LHC

REFERENCE LHC-TC-EC-0016

ENGINEERING CHANGE REQUEST

Installation of Low-Impedance Primary Collimators with BPMs (TCPPM) in IR7

Figure 1 — 3D view [**Error! Reference source not found.**] of the TCPPM collimator (SmarTeam code: ST0953409). Top: full collimator, with RF fingers. Bottom: sketch with left jaw only to show the 60 cm active length (obtained through blocks of different thickness).

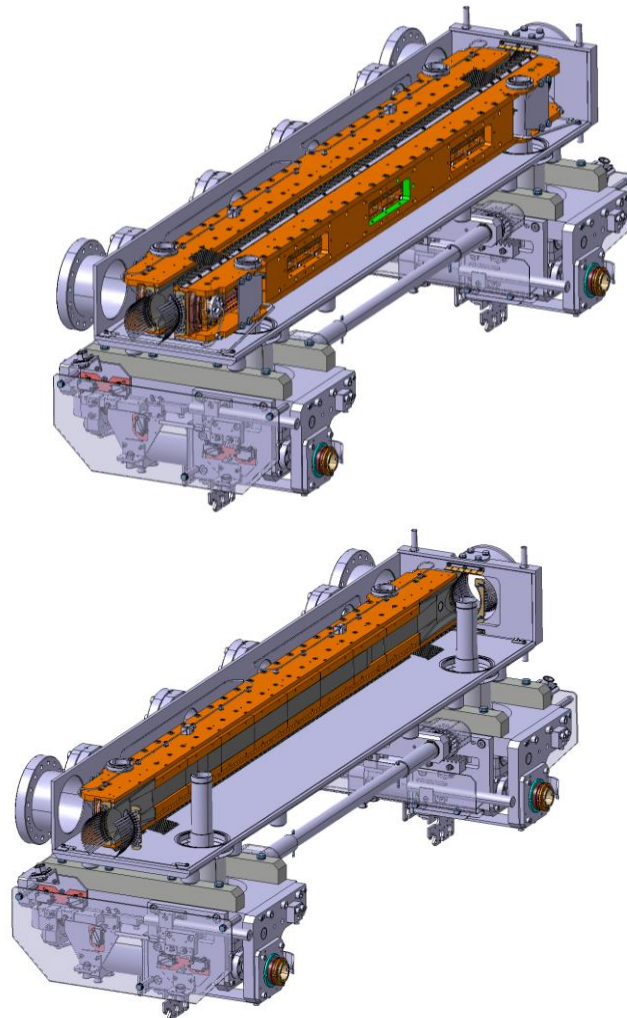
The present TCPPM design (see Figure 1) is similar to the one of the present TCPs [1]; among the most noticeable differences, there are the jaw material and the presence of in-jaw Beam Position Monitors (BPMs). In fact, the design foresees jaws made of a composite material (MoGr) obtained from Molybdenum and graphite, chosen for its lower impedance and similar robustness with respect to the jaw material of the present TCPs (Carbon-Fiber-Composite, CFC). The new material is characterised by a bulk resistivity a factor 5 lower than the one of CFC. The collimator jaws are equipped with BPM button pick-ups, for an easy determination of the beam closed orbit at the collimator and fast and precise alignment of the jaws. A third BPM is installed on the tank, to measure the beam position on the axis orthogonal to the one of cleaning.
